# SERVICE BULLETIN

## INSTALLATION OF REVISED V<sub>NE</sub> CARDS

All McDonnell Douglas Helicopter Systems (MDHS) MD600 Series Helicopters, serial numbers RN0003 thru RN0023.

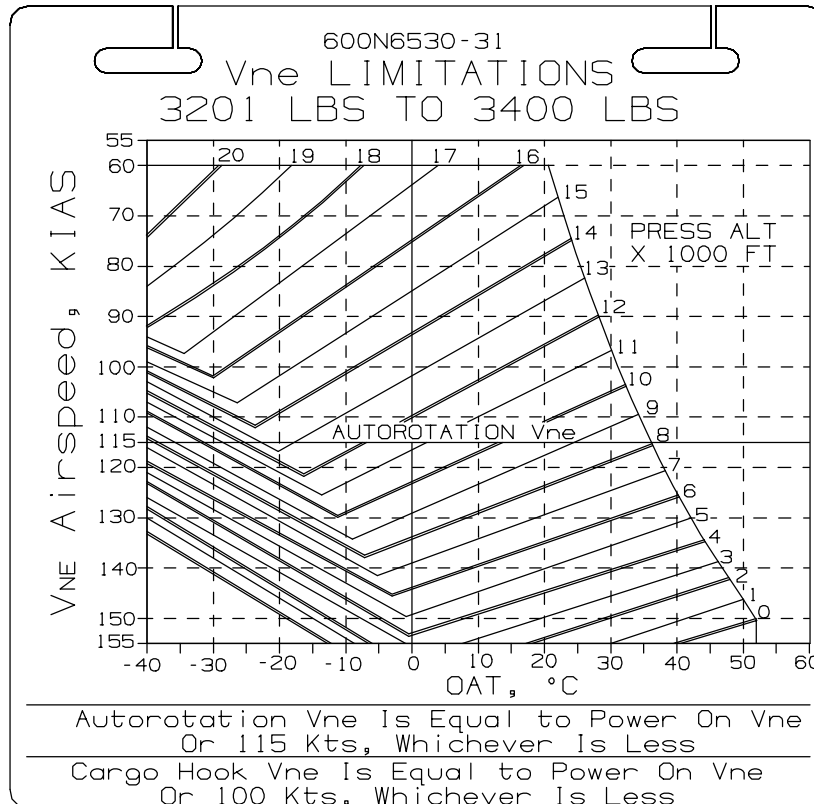
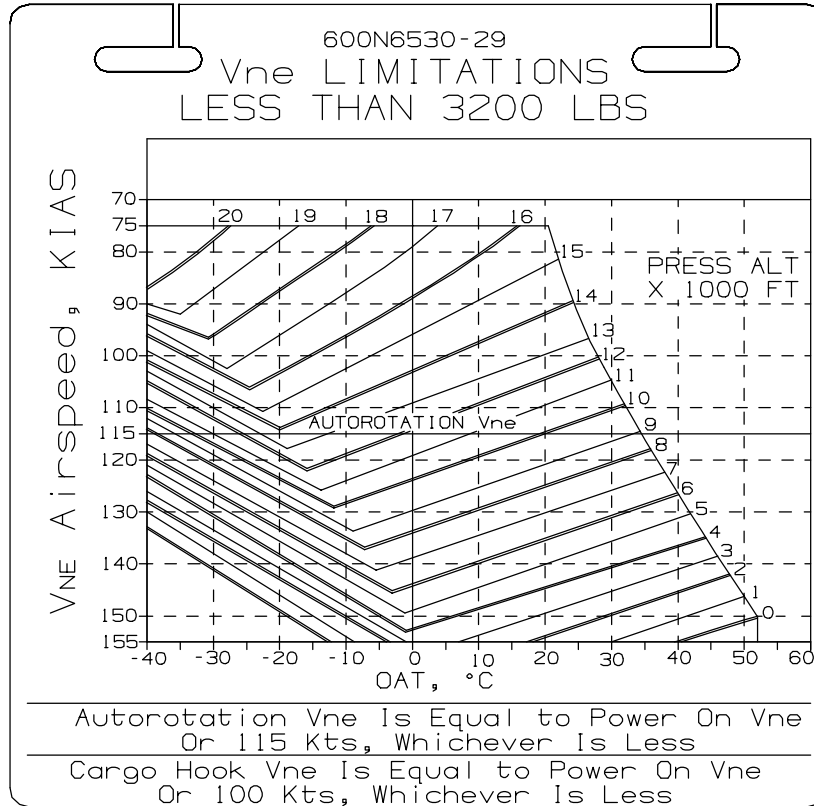
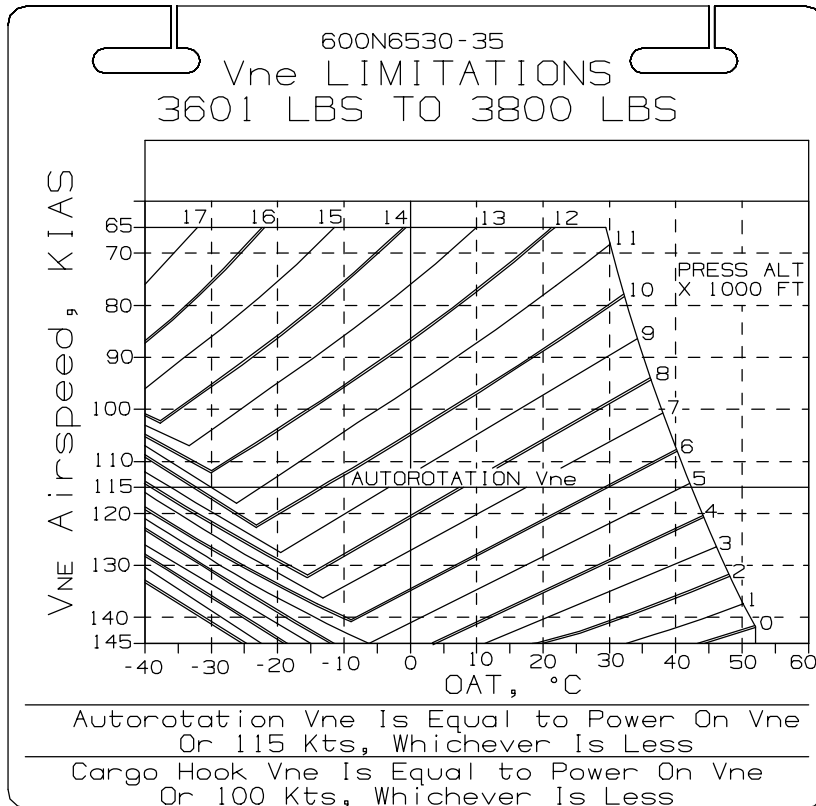
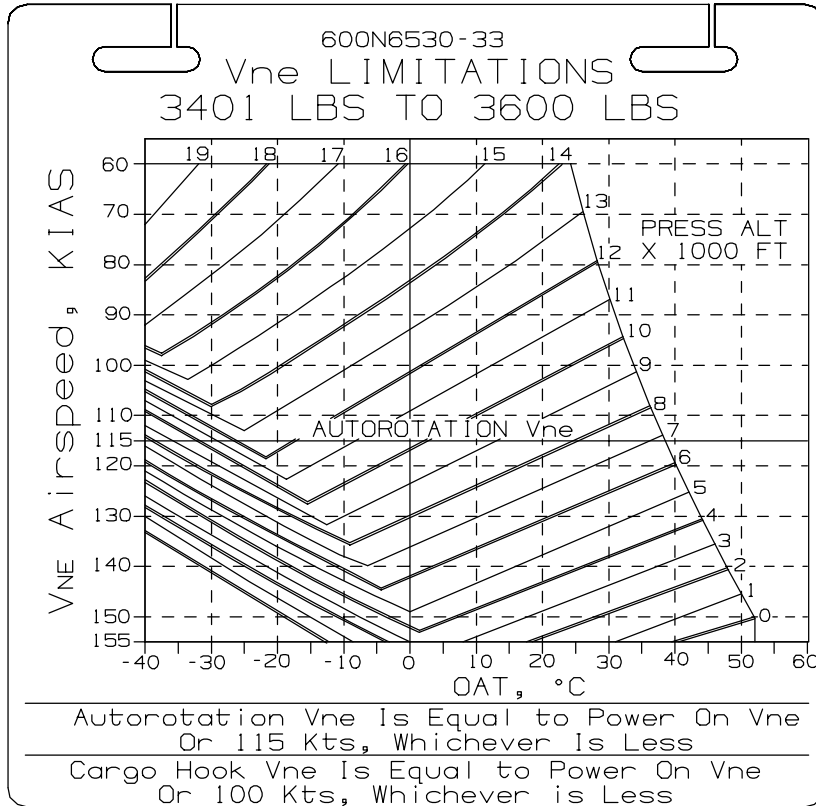
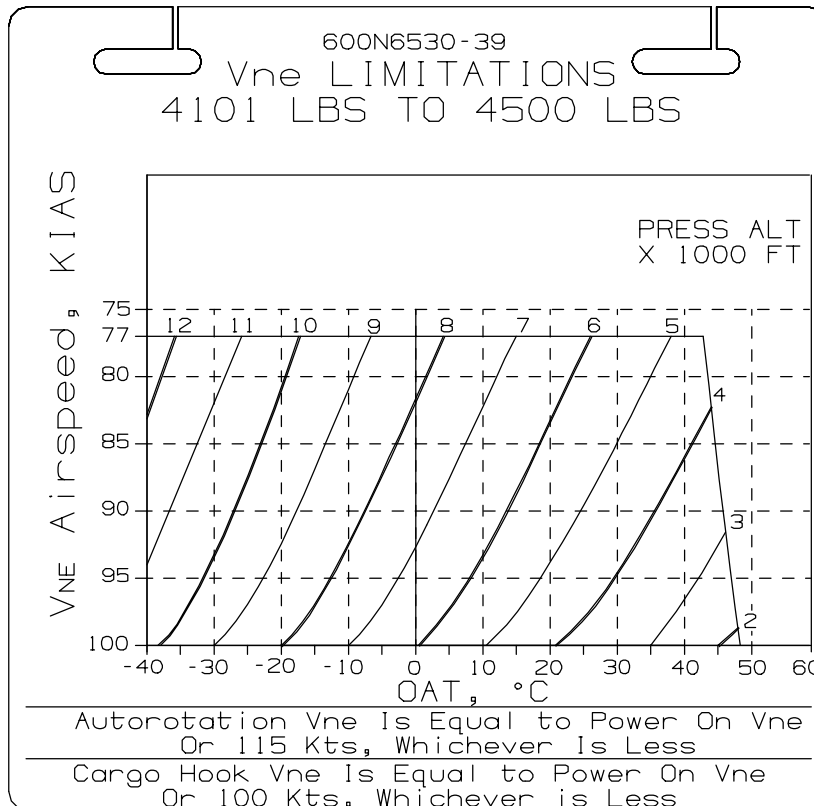
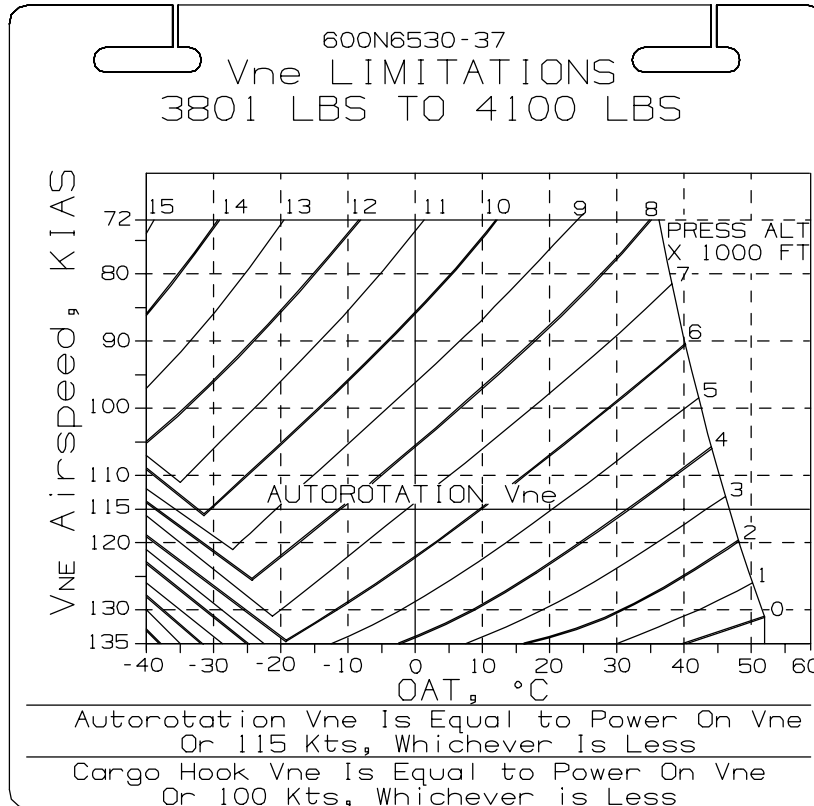
MDHS has recently completed cold weather testing which expanded the ambient temperature and start envelope to -40 deg. C. This change is included in Rev. 4 to the Rotorcraft Flight Manual (CSP-600RFM-1). This Bulletin provides immediate replacements of the existing V<sub>NE</sub> cards to allow helicopter operation at lower outside ambient temperatures. Failure to comply with the requirements of this Bulletin will unnecessarily limit cold weather operations.

Procedures in this Bulletin provide owners and operators with new V<sub>NE</sub> card alterations which will allow owners to operate in lower outside ambient temperatures.

**NOTE:** Ensure that the V<sub>NE</sub> placard part number remains on the temporary replacement placard when performing the following steps.

- (1). Cut out the attached V<sub>NE</sub> cards and temporarily replace the existing V<sub>NE</sub> cards with the cut out versions until a permanent replacement can be provided.
